MFN 07-311

Subject: **Response to Portion of NRC Request for Additional Information
Letter No. 80 - Containment Peak Pressure Analysis - RAI Numbers
6.2-140, 6.2-142, and 6.2-143**

**Response to Portion of NRC Request for
Additional Information Letter No. 80
Related to ESBWR Design Certification Application
Containment Systems
RAI Numbers 6.2-140, 6.2-142, and 6.2-143**

Figure 6.2-140-1. Post-LOCA Drywell Pressure for Seven-Day Period Bounding and Nominal Conditions, IC/PCC Pool Refill at 72 Hours

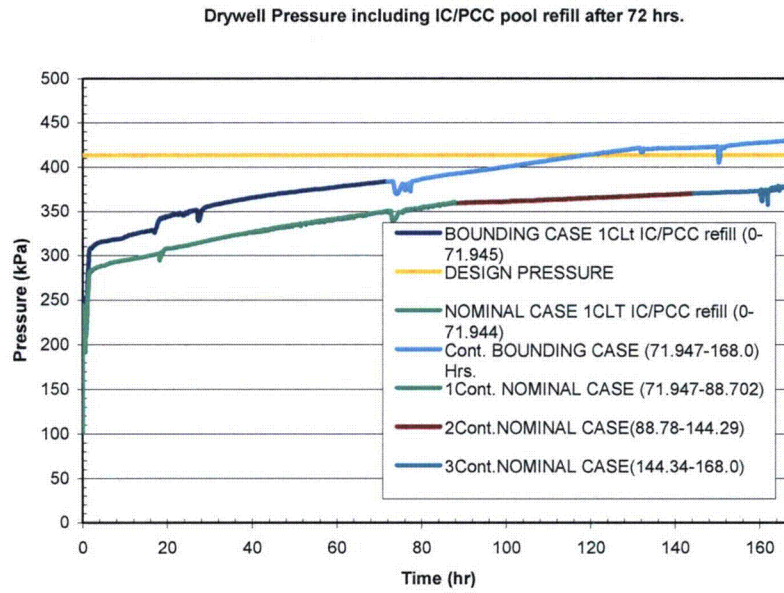
For the bounding case, DCD, Tier 2, Revision 1, Figure 6.2-12 for the containment pressure shows a short term peak of 344 KPa and long-term peak pressure of 340 KPa at 72 hours, which is increasing. Please justify that the containment pressure does not exceed the design pressure of 414 KPa after 72 hours.

The Passive Containment Cooling System (PCCS) is a passive engineered safety feature of the containment that will remove post loss-of-coolant accident (LOCA) decay heat from the containment for a minimum of 72 hours without operator action to maintain containment pressure and temperature within design limits. Beyond 72 hours, mitigating measures would be in place to keep the containment pressure and temperature within design. One of these measures consists of providing Isolation Condenser (IC)/PCC pool makeup for the PCCS to continue removing decay heat at a rate that will maintain the containment pressure and temperature within design limits. The analysis to determine the drywell pressure behavior for the main steamline break (MSLB) for the licensing bounding and nominal conditions including refill of the IC/PCC pool was performed utilizing the ESBWR TRACG code. The analysis results show that for licensing nominal conditions, the drywell pressure remains below the design pressure 413.7 KPa (60 psia) during the seven-day duration of the event. Under licensing bounding conditions, the results indicate that the drywell pressure remains at or below the design pressure for about 120 hours (five days) and increases to 430 KPa (62.4 psia), slightly above the design pressure by 16.3 KPa (2.4 psi) at the end of the seven-day period. The results for the bounding case are conservative. The decay heat and radiolytic gas generation were assumed not to change after the first four days, and these variables were kept constant for the remainder of the seven-day period (see Figure 6.2-140-1).

DCD Tier 2, Section 6.2, will be expanded in DCD Tier 2, Revision 4, to capture the results of the current evaluations of the proposed IC/PCC pool refill at 72 hours and use of PARS to ensure no radiolytic gas production after 72 hours as measures to further maintain the post LOCA containment pressure values below design pressure for the entire seven-day period.

Figure 6.2-142-1. Vacuum Breaker Flow for Nominal MSLB Case

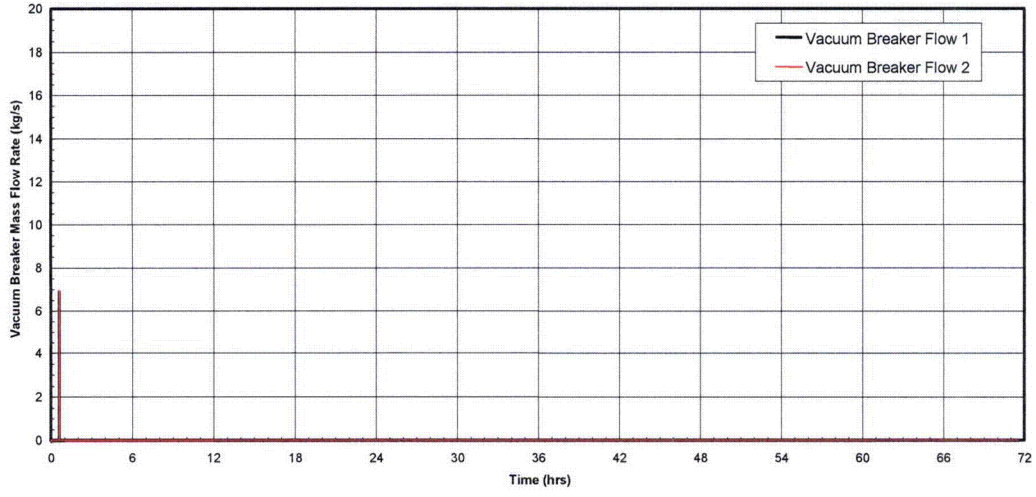
In response to NRC RAI 6.2-59, in Enclosure 1 to MFN-06-364 dated October 3, 2006, GE stated that "The ESBWR design uses 3 vacuum breakers. Assuming one vacuum breaker is out of service for the LOCA [loss-of-coolant accident] analyses, there should be 2 vacuum breakers available for the LOCA transient." Making 3 vacuum breakers available during a LOCA would appear to be more conservative considering that a higher rate of noncondensable flow from the wetwell to drywell would degrade the passive containment cooling system more than when only 2 vacuum breakers are available. Please explain this apparent nonconservative modeling of only 2 of 3 vacuum breakers available during a LOCA.

For the main steamline break (MSLB) with failure of one depressurization valve (DPV) at nominal conditions, vacuum breaker opening occurs twice at approximately 36 minutes into the transient. The vacuum breakers stay open for a short period of time (< 10 seconds). Vacuum breaker flow is shown in Figure 6.2-142-1.
